## Addendum #1

\*NOT TO SCALE. FOR LAYOUT PURPOSES ONLY!\*

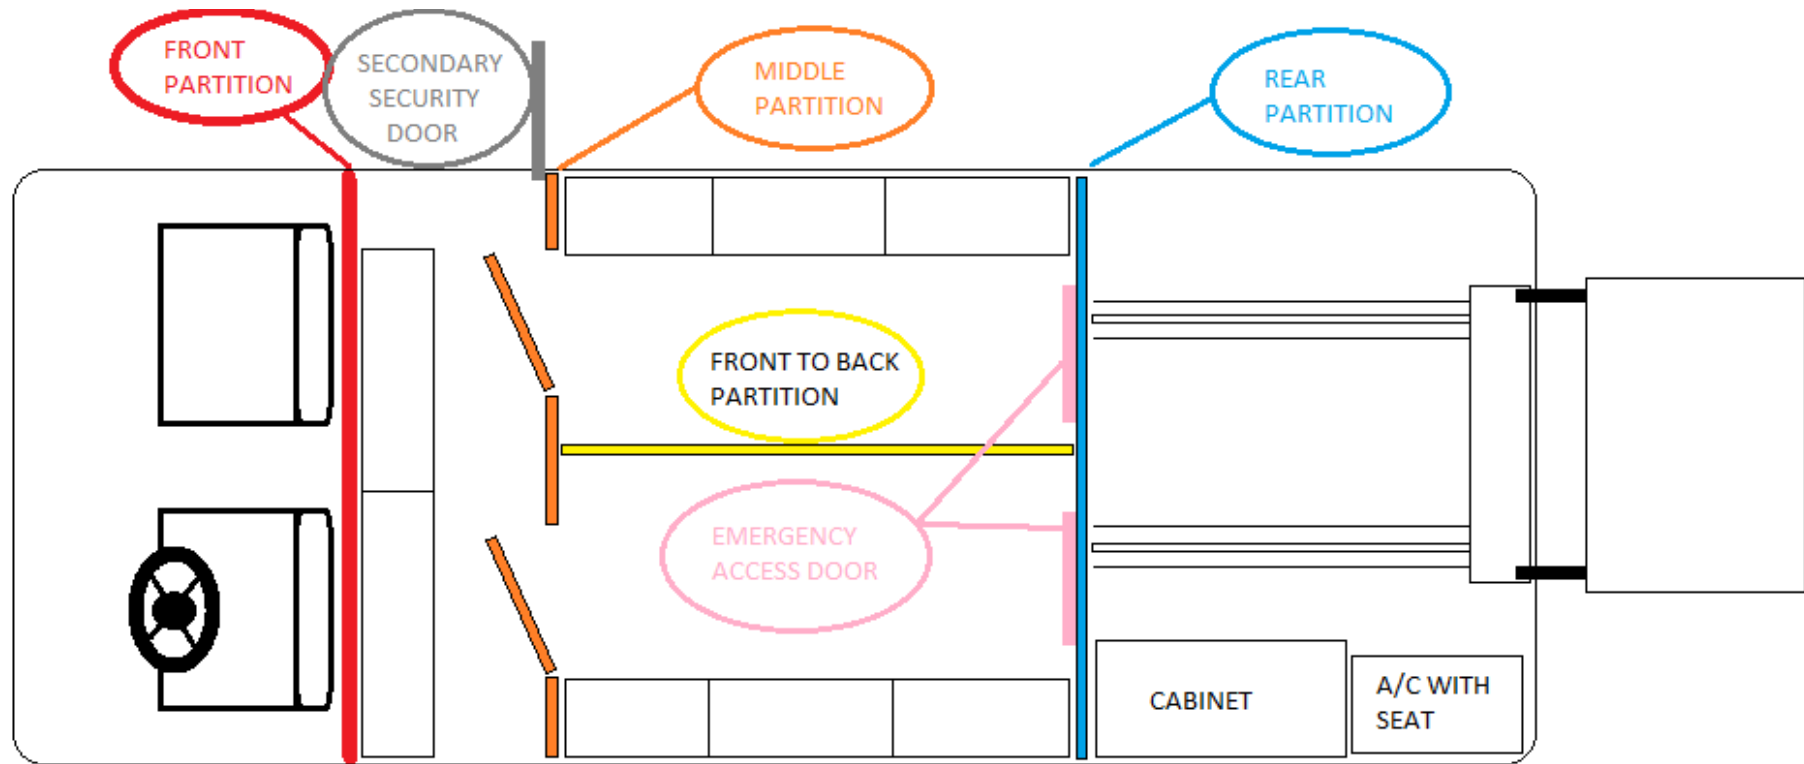
- **Question:** Wondering if there is a drawing? **Answer:** There is a drawing attached. For layout purposes only.
- **Question:** If we are following ADA guidelines for the transport of a wheelchair person 4 floor belts and lap and shoulder belt, ADA certified wheelchair lift? **Answer:** Reference Section H. (Wheelchair Tracks) and Section I. (Braun Wheelchair Lift)

- **Question:** The seats side facing with seat belts? **Answer:** Seats to be formed bench-seats with seat belts. Reference drawing for prisoner facing and Section F.
